SI 92/85

Second up date of A725 CD Player

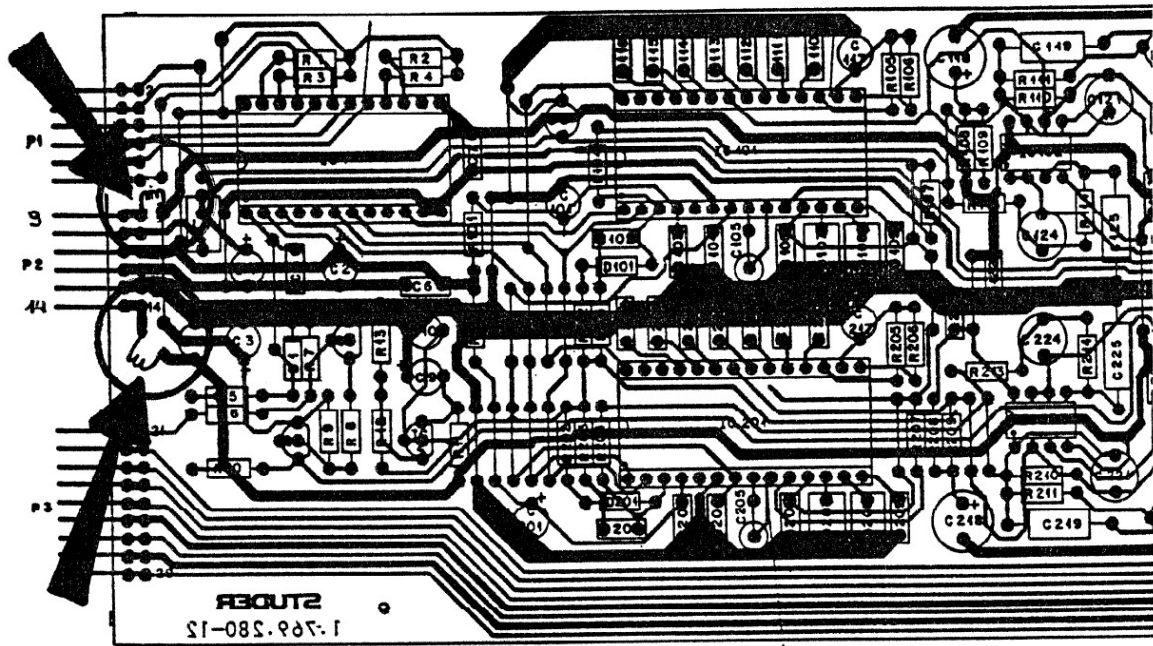
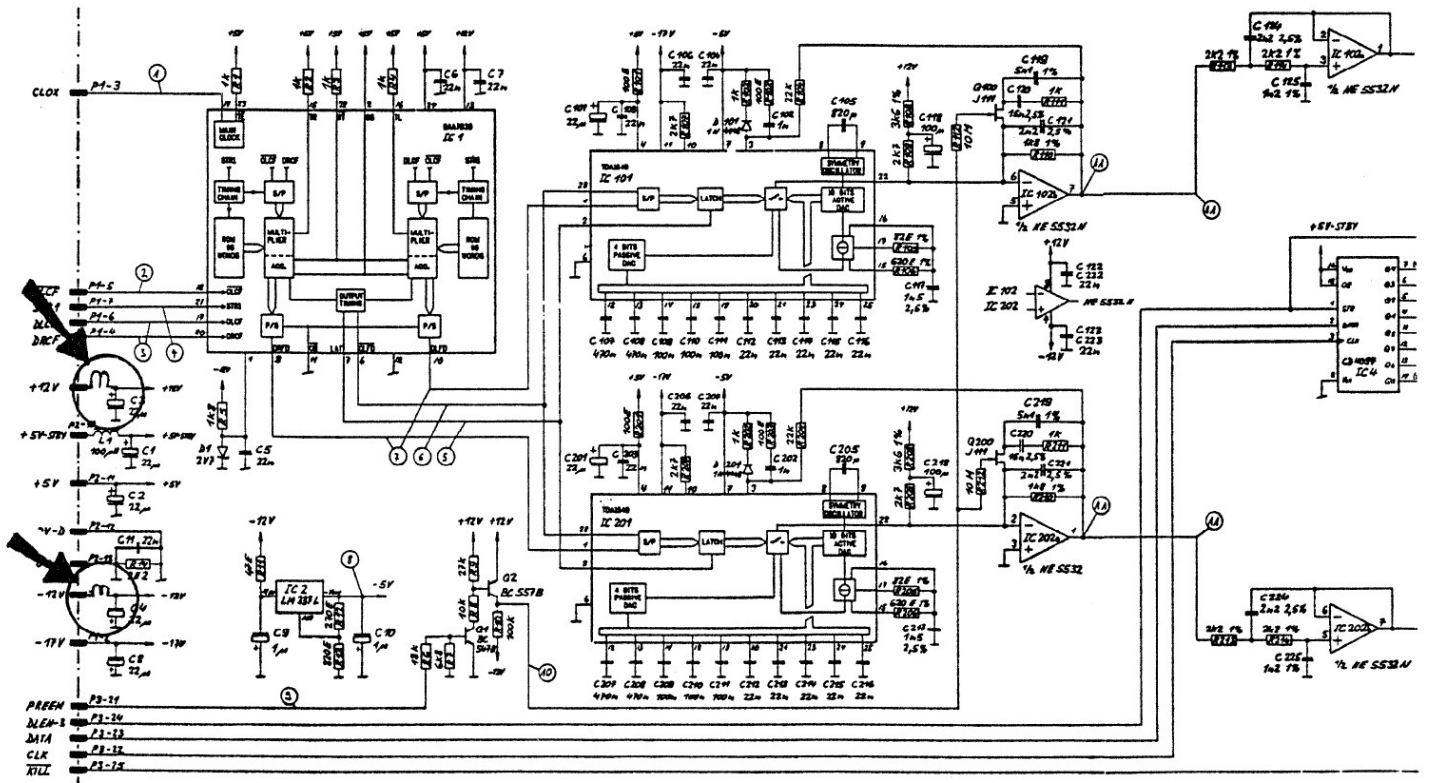
In Pause mode, low level disturbance may be audible on the audio out-
puts of the player. These are only audible if the audio signals are
monitored at very high level.

The interference signal level peaks between 83.5 dB and 86 dB below
maximum line level.
After the modification these signals drop below - 86 dB.

This interference is caused by peak currents drawn by the laser servo,

as it moves back and forth in PAUSE mode.
This servo may take a maximum of 300 mA for an abrupt radial correction,
and this causes spikes on the +/- 12 Volt power supply of the D/A Con-
verter.

The interference signals are eliminated by inserting a coil in the

+ 12 V and the - 12 V power supply line.
(100 uH, max. 170 mA, ordering number of the coil is 62.02.3101).

On the DAC PCB (1.769.285) the circuit connection of at P2 pin 9 and
at P2 pin 14 are to be interrupted, and the coils are to be inserted.
The coils need to be inserted near the P2 connector, before the capa-
citors C3 and C4.
